UNITED STATES PATENT AND TRADEMARK OFFICE

Office Action Summary	Application No. 10/530,683	Applicant(s) IMPELLIZZERI, FREDERIC	
	Examiner MARY HOFFMAN	Art Unit 3733

DETAILED ACTION

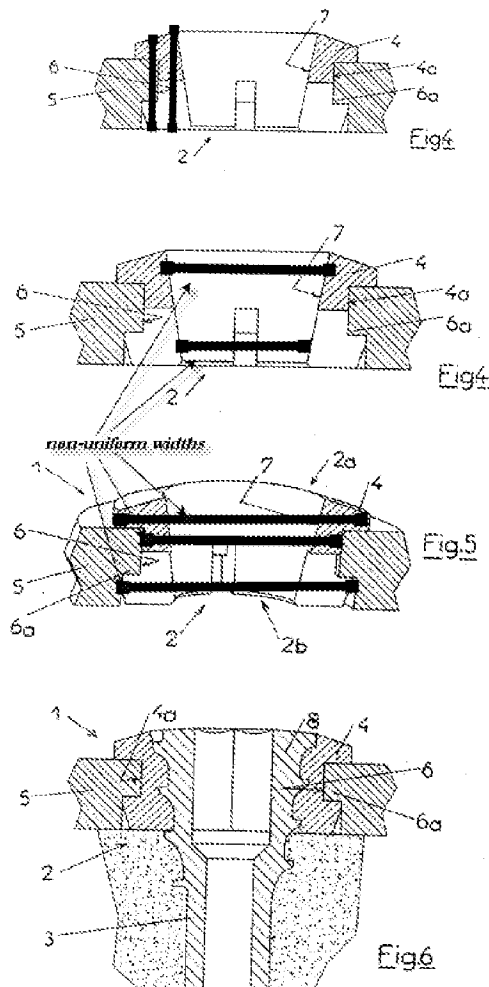
“uniform width” in claim 19, line 9. The inserts shown in the figures do not appear to be uniform in width; rather, the width appears to vary. In addition, the term “uniform width” is not disclosed in the specification. The term “uniform width” also appears in claim 28, line 9.

Applicant argues that the insert width is disclosed as uniform in FIGS. 4-6. If the examiner is misinterpreting Applicant's claims and arguments, the Applicant should further clarify. As shown below, the insert does not appear to have any uniform width. Rather, the width appears variable.

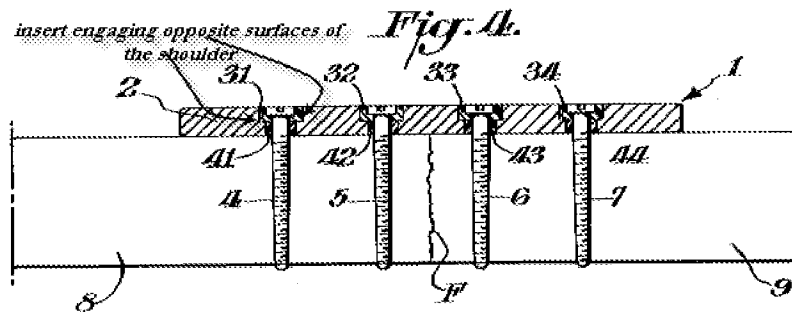
Applicant argues also argues that Kummer et al. in view of Frigg et al. does not disclose the claimed insert/shoulder engagement and the claimed self-tapping positioning. Regarding Applicant's argument that Kummer et al. in view of Frigg does not show that each insert fixedly engages opposite surfaces of the shoulder of the

opening, the examiner respectfully disagrees. As seen below, the insert clearly engages opposite surfaces of the shoulder.
